Informal document No. **GRPE-51-16**  
(51st GRPE, 16-20 January 2006,  
agenda item 1.3.)

**Modified document 2006-08**

**For consideration by GRPE experts by 10 February 2006**

**17 January 2006**

**Figure C4**

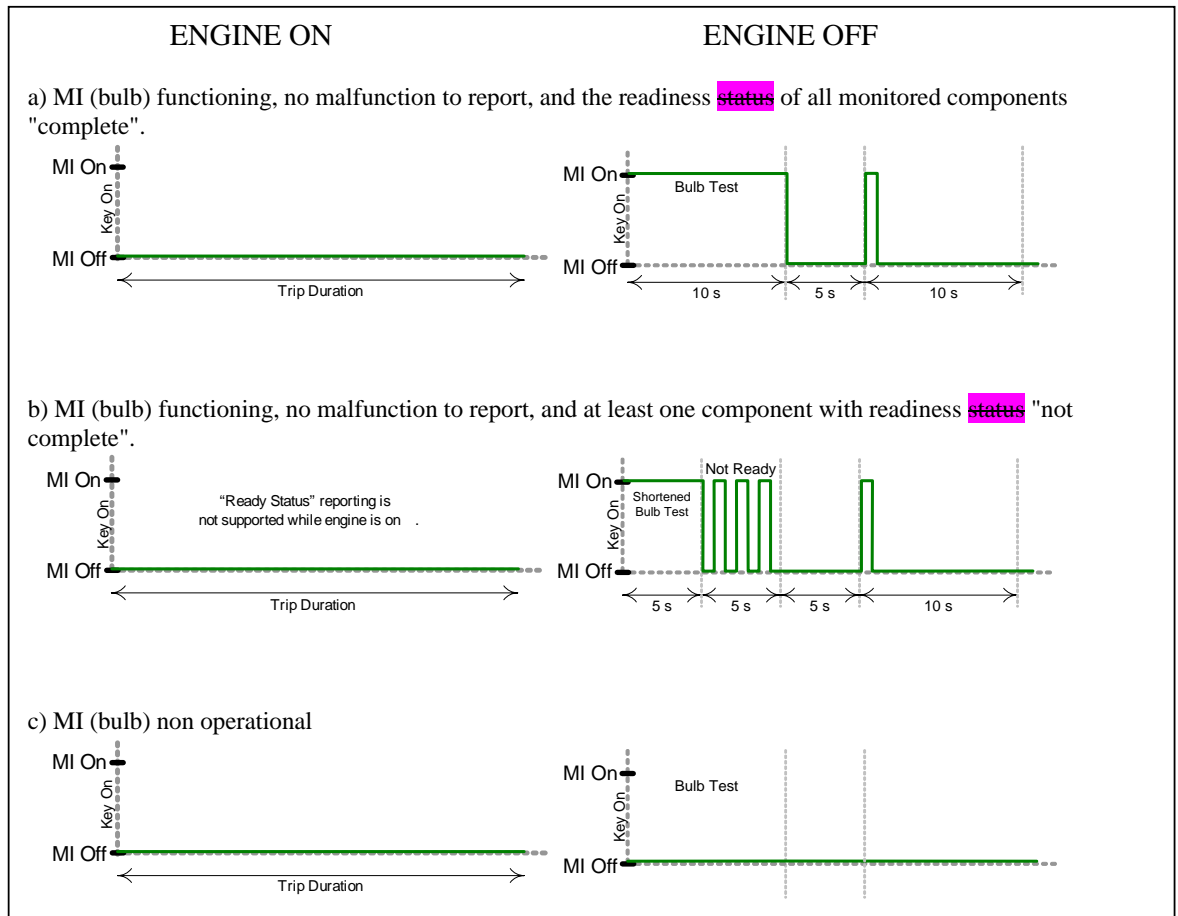
Figures C4 and C5 illustrate the prescribed activation strategies at key on, engine on or off. *Figures to be amended to comply with the written proposal*

**Bulb test and readiness indication** *Figure to be amended to comply with the written proposal*
